Project: IEEE P802.15 Working Group for Wireless Personal Area Networks (WPANs)

Submission Title: Simplifying color-function and blinking-notification support in IEEE 802.15.7

Date Submitted: 16th May 2011

Abstract: In this contribution we address CIDs 312 and 308 from the second sponsor-ballot round. We propose a major revision and unification of the color-function and blinking-notification support that puts most of the functionality where it belongs, i.e. in the next higher layer.

Figure 35—Example of CVD frame usage MSC for association

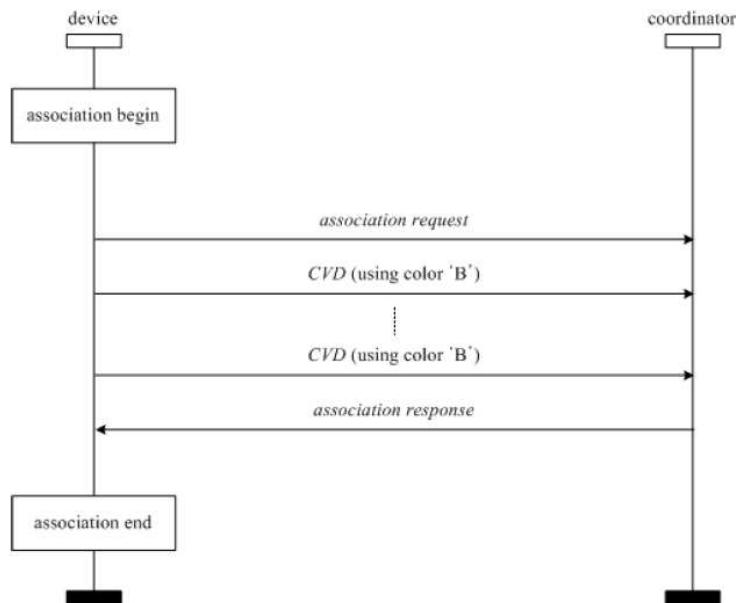
- ❑ 5.1.12.1: Association etc. initiated in the next higher level above MAC (→ MLME).
- ❑ 5.1.12.2: ACK/noACK signaled to next higher layer via “status” in MCPS-DATA.confirm.

Observations and issues

- ❑ **Do we need a MAC implementation?**
 - Arguments for choosing implementation in MAC sublayer commonly are
 - MAC-specific task
 - Needs to access MAC-internal parameters

- High processing speed
 - Color-function support does not mediate medium access (MAC!)
 - Information for invoking and configuring color-function support has to be known above MAC

- Due to very low time resolution of human eye (~ 10 ms) execution of color function not time critical
- ❑ **Thus: implementation in MAC NOT necessary, even more it is an APPLICATION!**

- ❑ **Enable invocation CVD-frame transmission through next higher layer**
- ❑ **Create unified interface between MAC and next higher layer**
- ❑ **Needed**
 - “Send CVD frames” primitive. Input: color code; number of frames; duration; repetition frequency; also: feedback as output
- ❑ **Suggested features**
 - Input: number of frames, color code, duration, repetition time
 - Output: feedback from MAC on whether
 - Color function is supported
 - Request was heeded
 - Color-function temporarily not possible
 - ...

- ❑ **MLME-
CF.send(CVDRepetitions,CVDColor,CVDD
uration,CVDCycleLength)**
- ❑ **Issued from next higher layer to MAC**
- ❑ **Primitive for requesting transmission of
CVD frames**
 - If arguments empty → default/current settings are used
 - Default settings can be inquired with MLME-GET and can be changed with MLME-SET

Figure 37—Example of MSC for CVD frame usage for file-transfer status indication

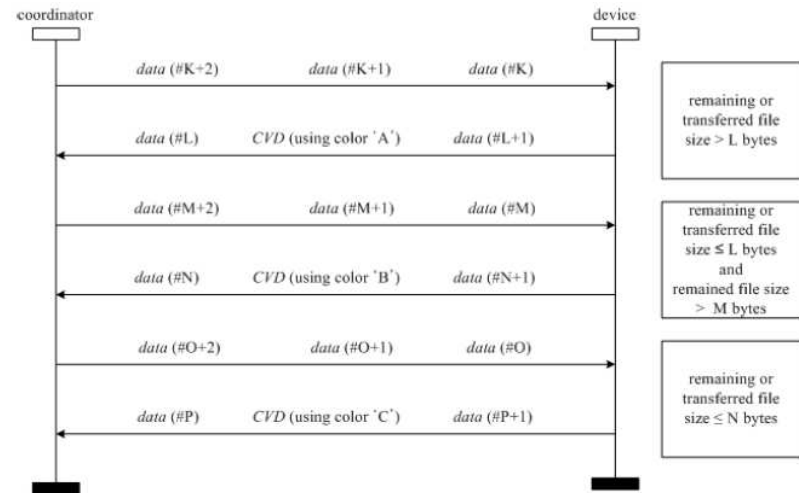
- ❑ Channel-quality indication (MpdulinkQuality) signaled to higher layer via MCPS-DATA.indication
- ❑ File size remaining usually only known above MAC.
